PLAN VIEW FRA. US-33
STA. 279+07 TO STA. 289+07

FRA-33-20.69

QUANTITIES FRA. US-33
STA. 299+07 TO STA. 309+07

PLAN VIEW FRA. US-33
STA. 309+07 TO STA. 319+07

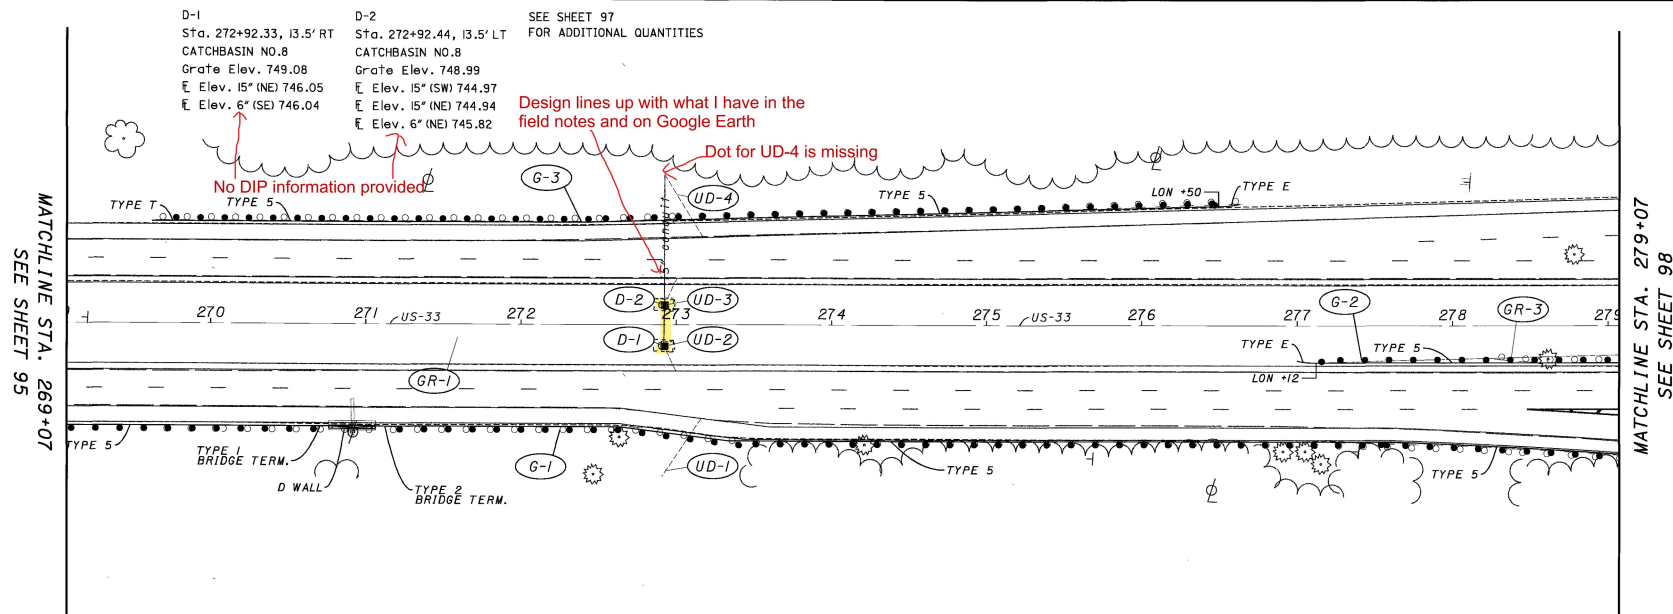
LOCATION				QUANTITIES												REMARKS	
REF NO.	STATION	STATION	SIDE	202	202	202	202	202	202	603	603	604	604				
				CATCH BASIN REMOVED	PIPE REMOVED, 24" AND UNDER	GUARDRAIL REMOVED	ANCHOR ASSEMBLY REMOVED TYPE A	ANCHOR ASSEMBLY REMOVED TYPE T	ANCHOR ASSEMBLY REMOVED FOR REUSE TYPE E-98	6" CONDUIT TYPE F	15" CONDUIT TYPE C	CATCH BASIN NO. 8	PRECAST REINFD CONCRETE OUTLET				
	FROM	TO		EACH	FT.	FT.	EACH	EACH	EACH	FT.	FT.	EACH	EACH				
UD-1	272+91		RT		10					10							
D-1	272+92		RT		10						10	I	I				
UD-2	272+92		RT		10					10							
UD-4	272+92		LT		10					10			I				
D-2	272+92		LT		20						20	I					
UD-3	272+92		LT		10					10							
GR-1	269+67	274+07	RT			890			I								
GR-2	269+65	276+65	LT			638		I	I								
GR-3	278+27	279+07	RT IN			55	I		I								
				These catch basins have been removed

E Elev. 15° (NE) 743.71 ← This is the only pipe that should be connected to this inlet
 E Elev. 6° (N) 745.69 ←
 E Elev. 6° (SW) 745.69 ← NO DIP information provided
